Technical Service Bulletin: tsb100149

Released Date: 22-Jan-2002

New LTA Pipe Hoses

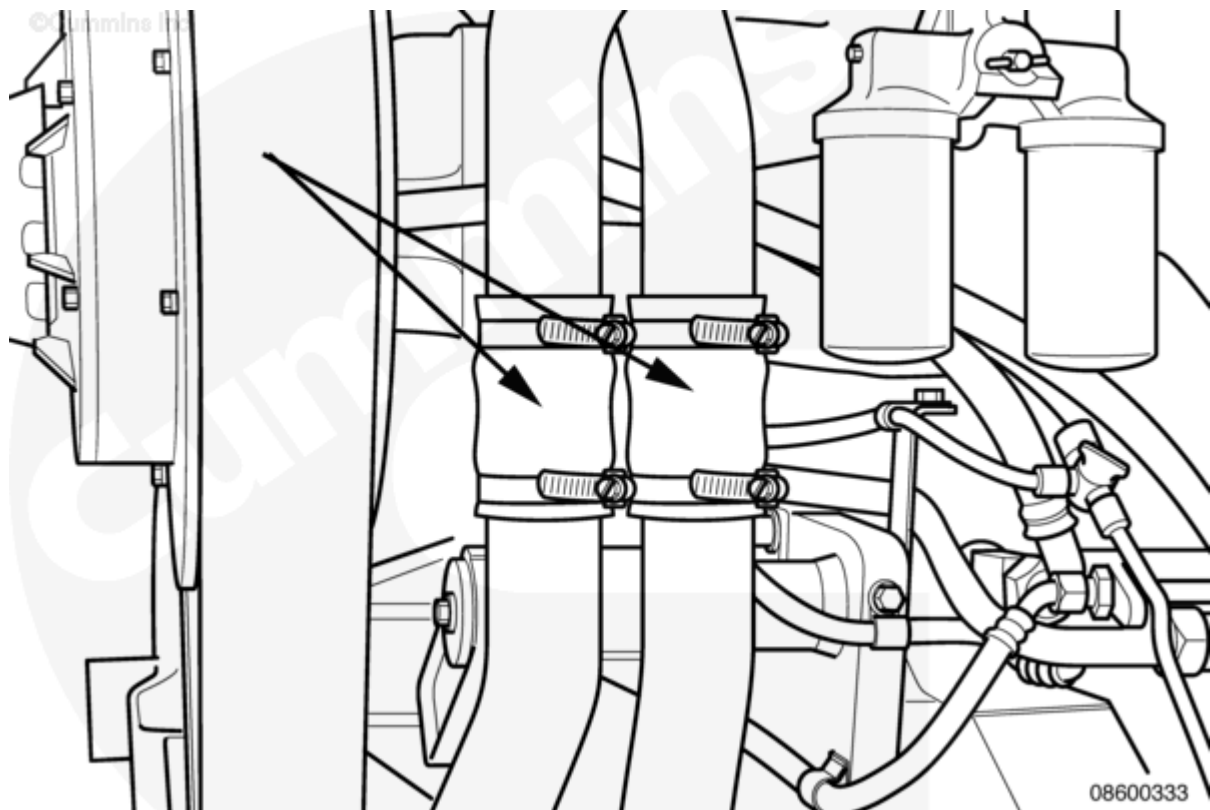
This Technical Service Bulletin introduces new low temperature aftercooling(LTA) pipe hoses for the QSK45 and QSK60 engines. The new hose has been released for improved durability.

The old hose, Part Number 3073123, is a three ply design using glass fibre reinforcement.

The new hose, Part Number 4080544, is a four ply design using a polyester fibre reinforcement.

The new LTA pipe hose went into production at the Daventry Engine Plant with engine serial number first 33150762.
